**STATE SIGNIFICANT DEVELOPMENT:
(SSD 7665)
*Sydney Opera House - Safety, Accessibility,
Venue Enhancement and Entry Foyer
Refurbishment Works***

Environmental Assessment Report
Section 89H of the
Environmental Planning and Assessment Act 1979

May 2017

Figure 4: Proposed new follow spot room at the rear of the JST (shown in blue) (Source: RfS)

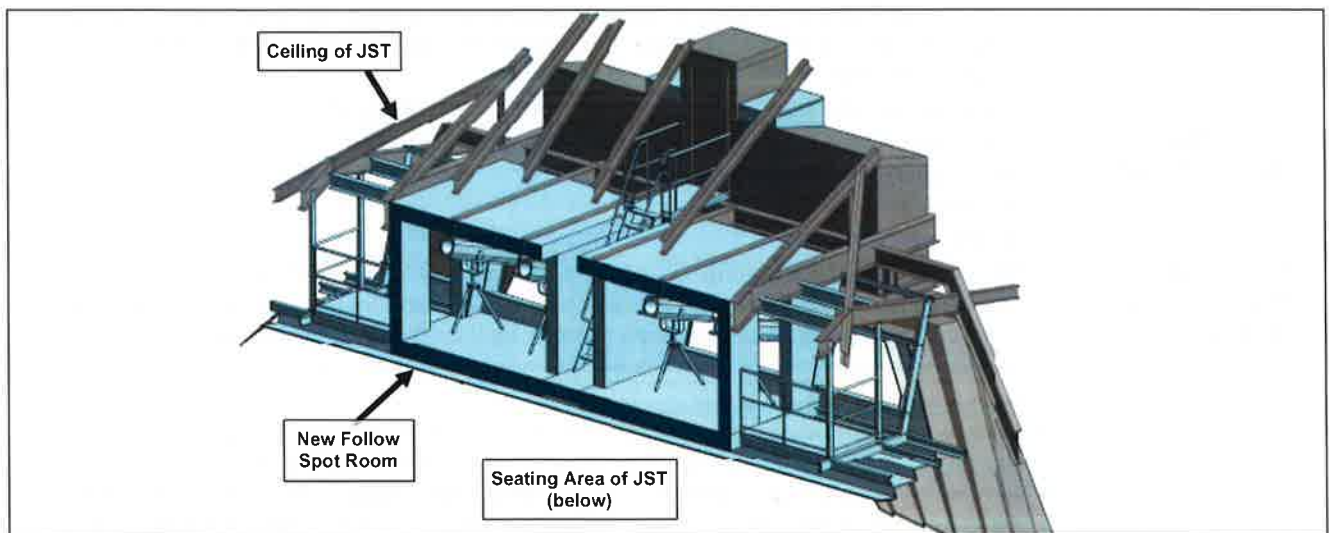
Council initially raised concern with the proposed alterations to the alignment of the ceiling profile and use of materials for the proposed follow spot room. However, the Applicant revised the design as part of the RtS, and no further issues were raised by Council in response to the revised design.

The Department notes the proposed follow spot room is discreetly located at the rear ceiling of the JST, and the proposed works would be largely unnoticed. The Department is satisfied the design of the follow spot room has been amended to address Council's concerns, that it would not result in any significant impacts to the spaces or building fabric within the SOH, and that it would provide functional benefits to the JST, including improved stage lighting for performances and events held in the JST.

Figure 5: Location of proposed new office accommodation (ground level and mezzanine level) (shown in purple) (Source: RtS)

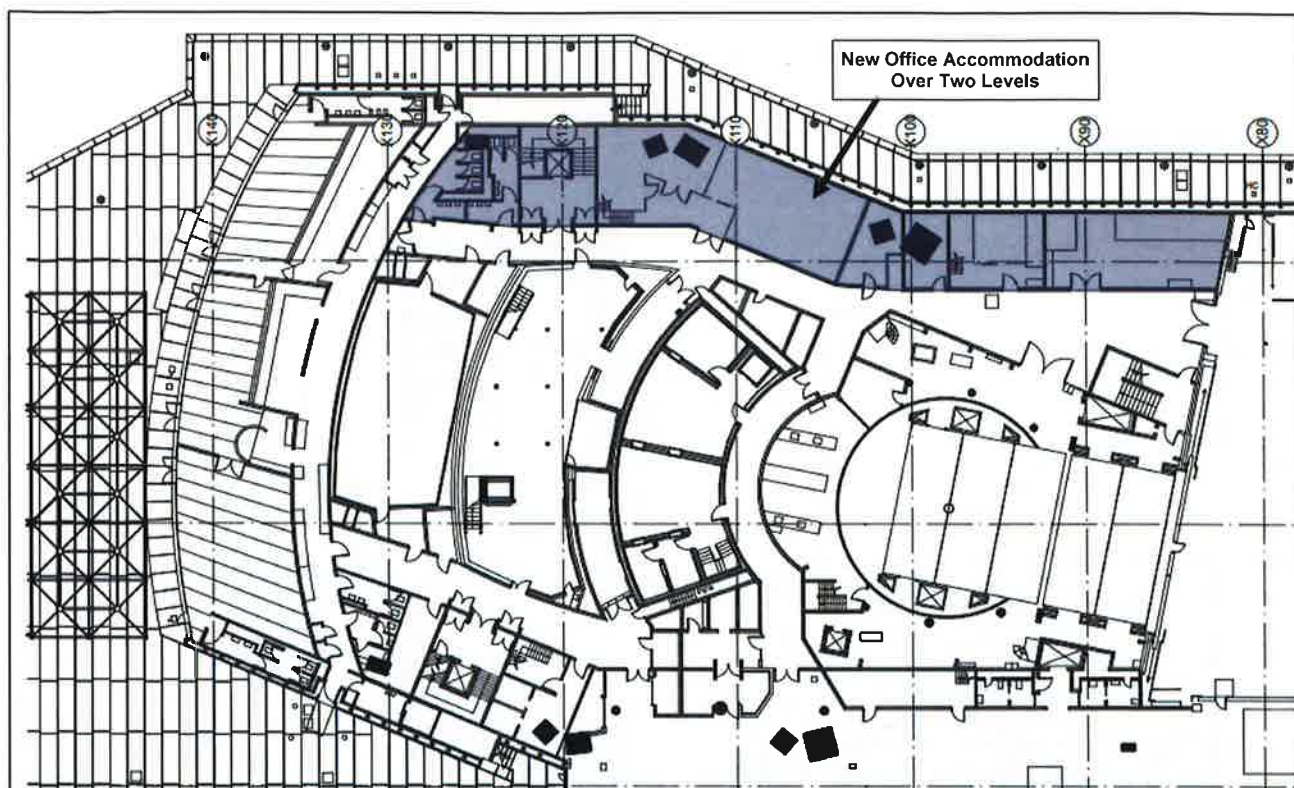
The Heritage Council and Council originally raised concerns with the provision of two new slot windows along the eastern façade of the SOH building to provide natural light and amenity for the office accommodation. These concerns were addressed in the RtS and the proposed slot windows were subsequently removed from the proposal. Council advised it supports the removal of the slot windows although has concerns about the ventilation and lighting in the office accommodation area. The Applicant has committed to providing alternative lighting and ventilation to the office accommodation area in accordance with the National Construction Code requirements. No other issues were raised in submissions regarding the office accommodation.

Figure 10: Layout of proposed entry foyer refurbishment (Source: EIS)

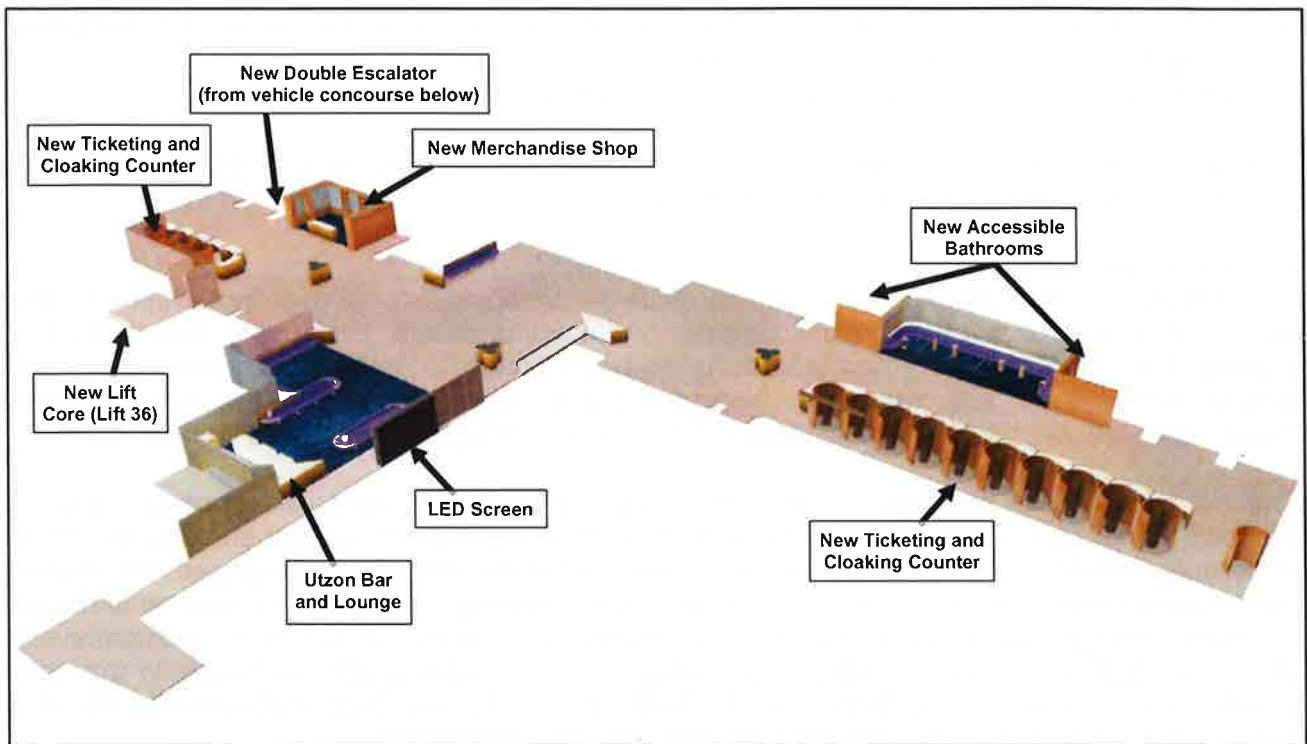
Council raised concern with the proposed replacement of the existing stairs with a new double escalator, advising the proposed aluminium materiality of the escalators would be inconsistent with the original bronze/brass material palette, and would detract from the character of the space.

In response to Council's concerns, the Applicant undertook further consultation with the Eminent Architects Panel (EAP) regarding the proposed materials for the escalators. The EAP determined the proposed materials for the escalators should match the precedent set with the existing six escalators in the SOH building, which have aluminium finishes. The EAP therefore did not recommend changing the proposed materials for the escalators in response to Council's concerns.
